PARTS & SERVICE NEWS

REF NO.	AT04824
DATE	Jun. 4, 2004

SUBJECT: REPAIR PROCEDURE FOR TAIL GATE (OPTION) ON HM300-1

PURPOSE: To introduce modification procedure to replace the tail gate on HM300-1 articulated dump trucks with the improved parts (optional)

Photo. 1

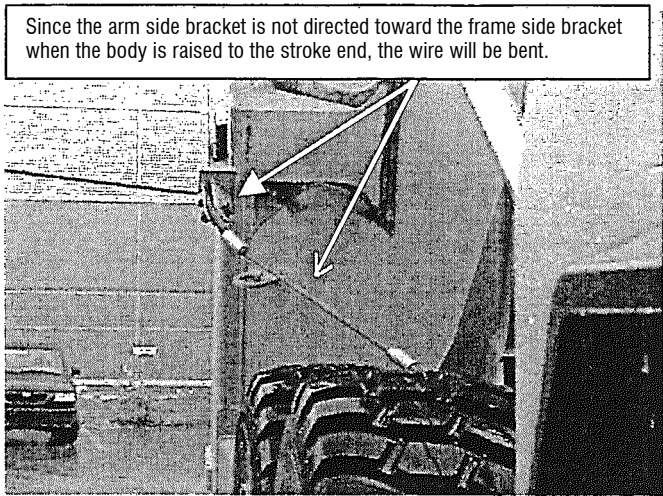
- (1) The mounting angle of the wire mounting bracket is changed to make a structure where the wire may be pulled straight forward when the body is raised to the stroke end.

Fig. 1

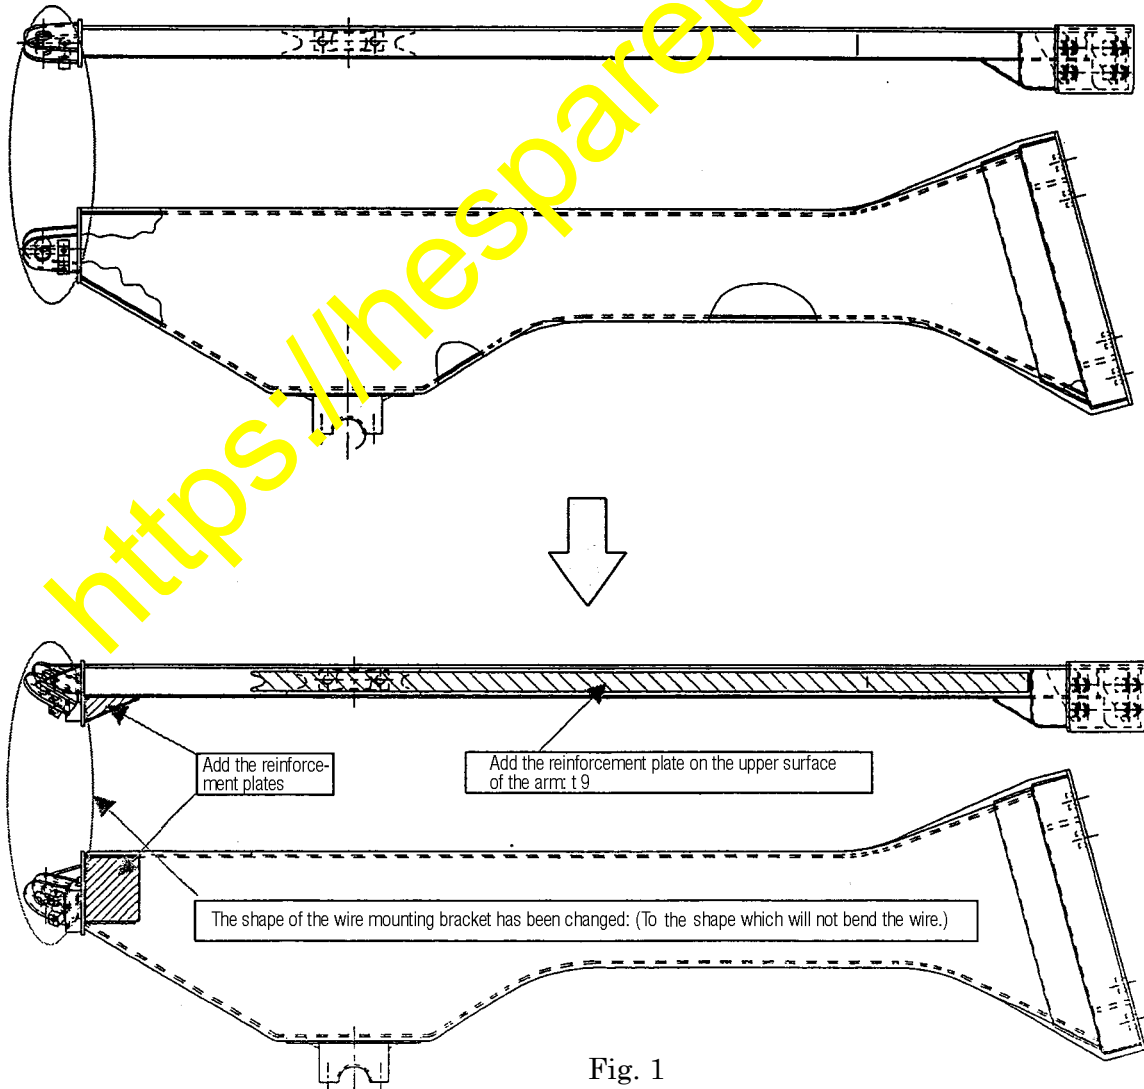
- (2) To prevent deformation of the arm, add the reinforcement plates to the upper surface and to the rear section of the wire mounting section to increase the rigidity.

Fig. 4

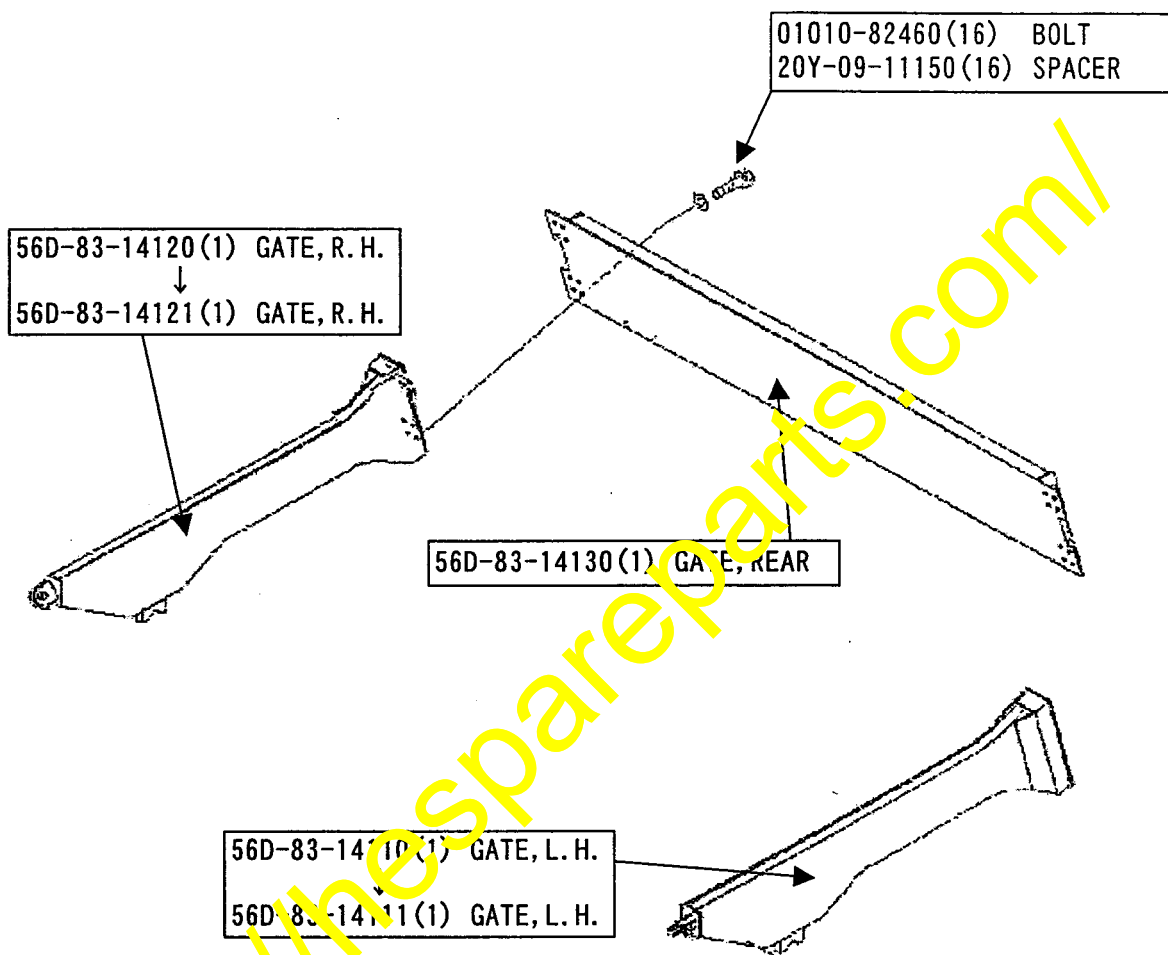
- (3) Replace the current gate, L.H. with the new gate, L.H. 56D-83-14111 and replace the current gate, R.H. with the new gate, R.H. 56D-83-14121 and make the tail gate sub-ass'y with them using the bolts (01010-82460) and spacers (20Y-09-11150). Tighten the bolts (01010-82460) temporarily when making the gate sub-ass'y and tighten them at the specified tightening torque after installing the tail gate sub-ass'y onto the vehicle body.
